TITLE : AIR CONDITIONING – AIR DISTRIBUTION AND RECIRCULATION – REPLACEMENT OR  
MODIFICATION OF THE RECIRCULATION FANS 14HG AND 15HG AND MODIFICATION  
OF THE ELECTRICAL WIRING

MODIFICATION No. : 26369K2212

This page transmits Revision No. 01 of Service Bulletin No. A320-21-1109.

SERVICE BULLETIN No. : A320-21-1109

Figure 5 Sheet 1  
 Modification of the Wiring Between the Rear Panel 120VU and the Rear Circuit Breaker Panel 122VU

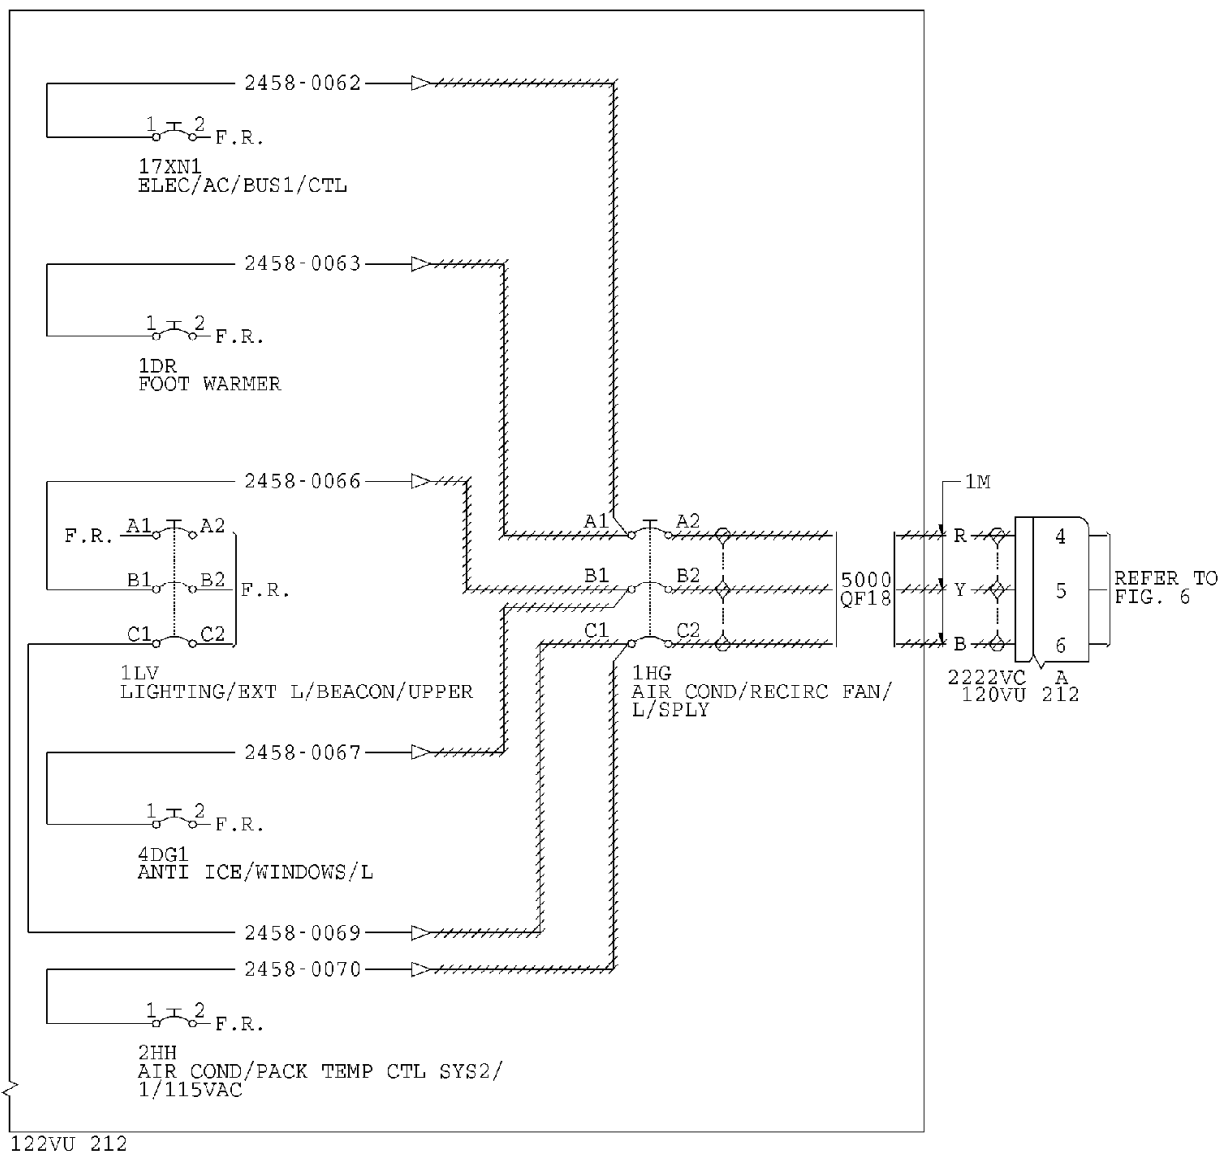
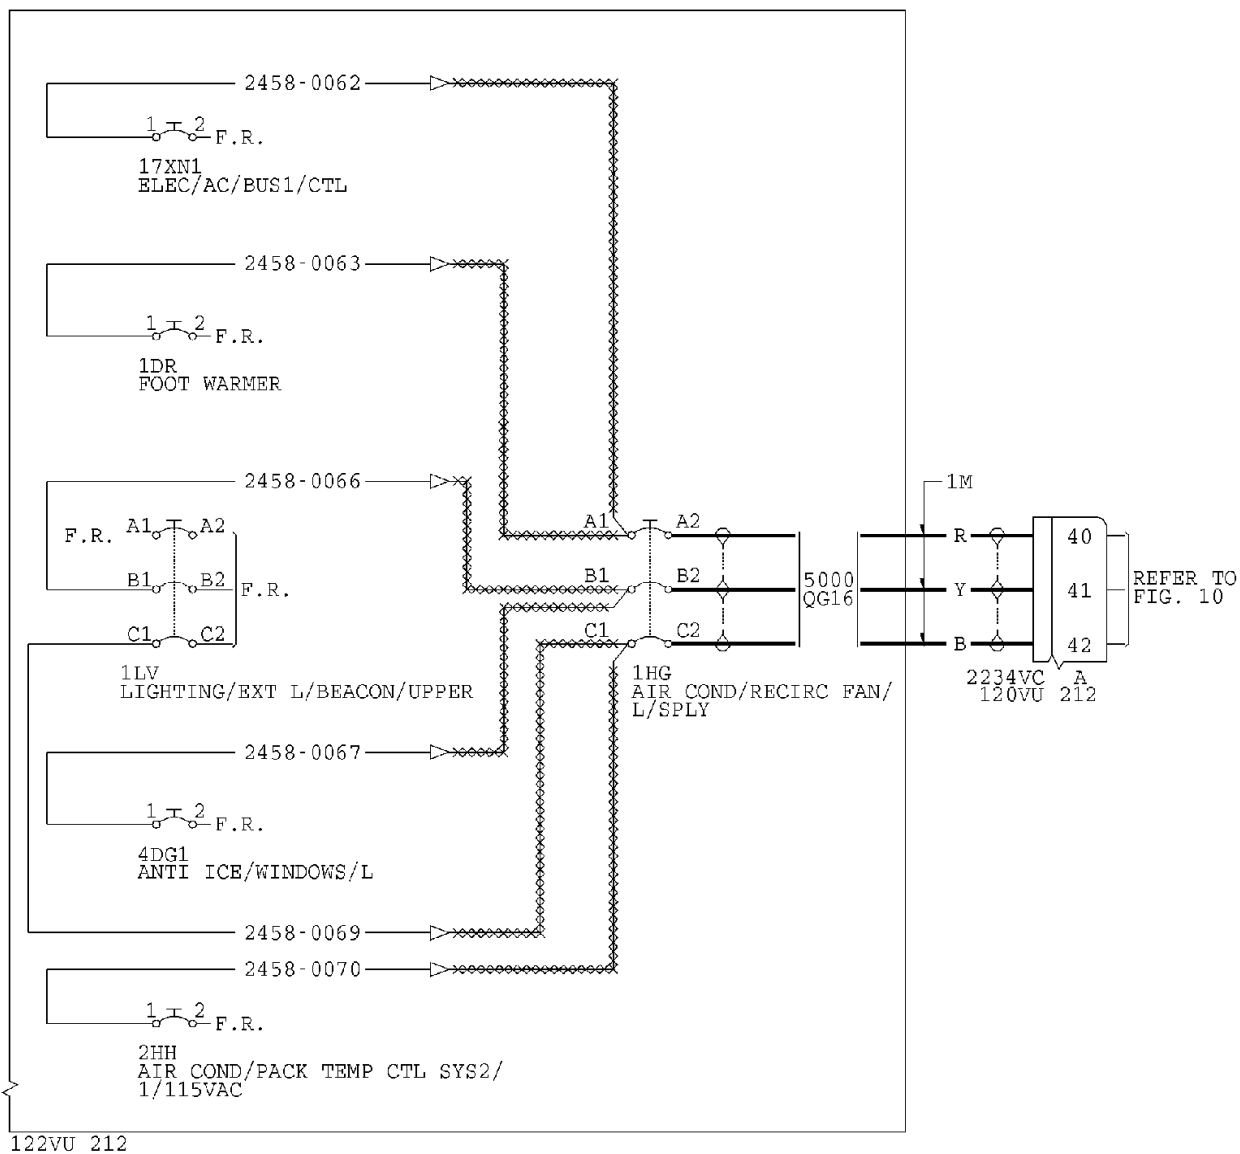
Figure 5, sheets 1 and 2 updated.

Figure 20 Sheet 1  
Wiring Diagram for the Recirculation Fans 14HG and 15HG between the Interface  
Connectors and the Fan Connectors

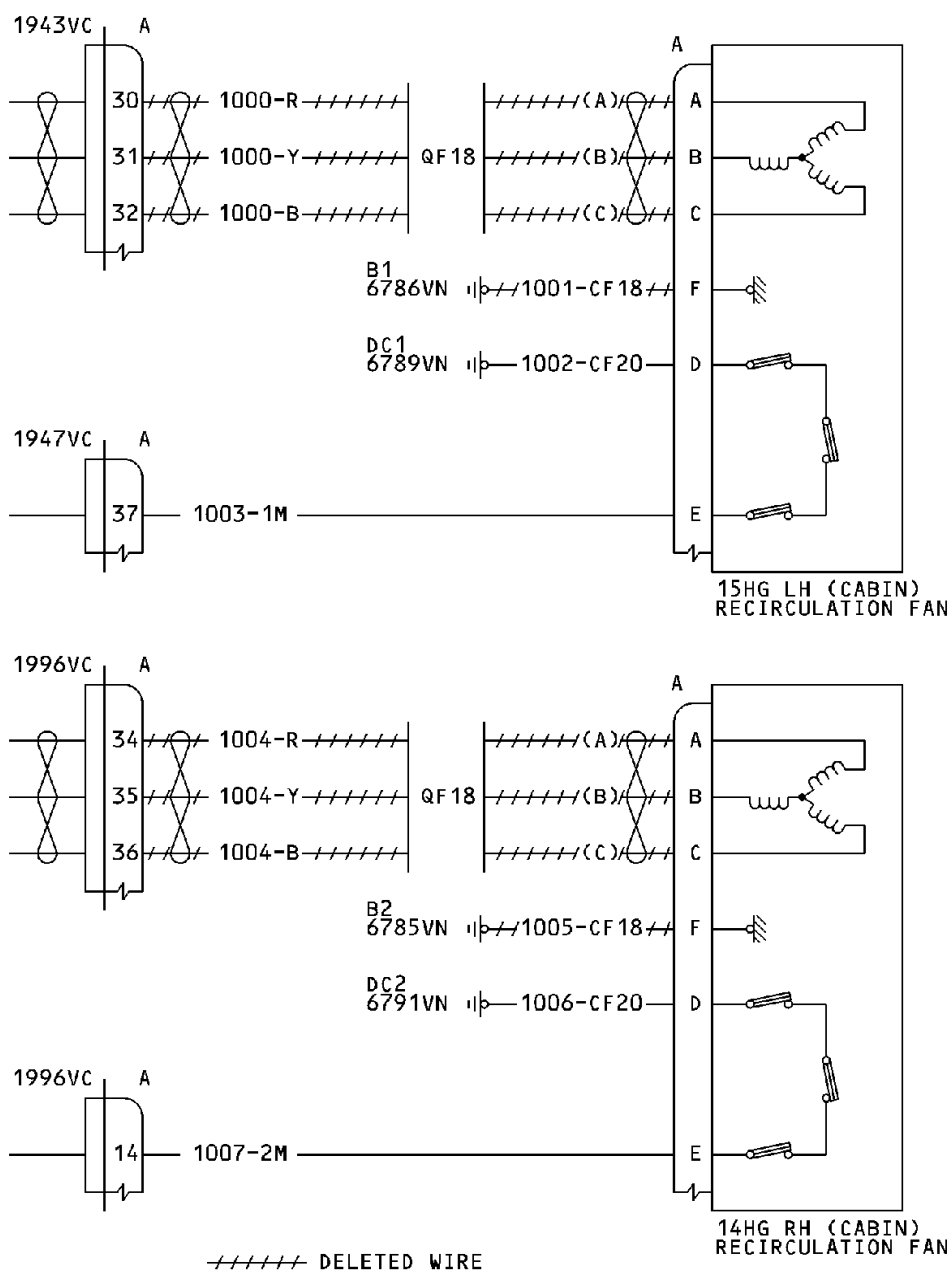
Figure 20, sheets 1 and 2 updated.
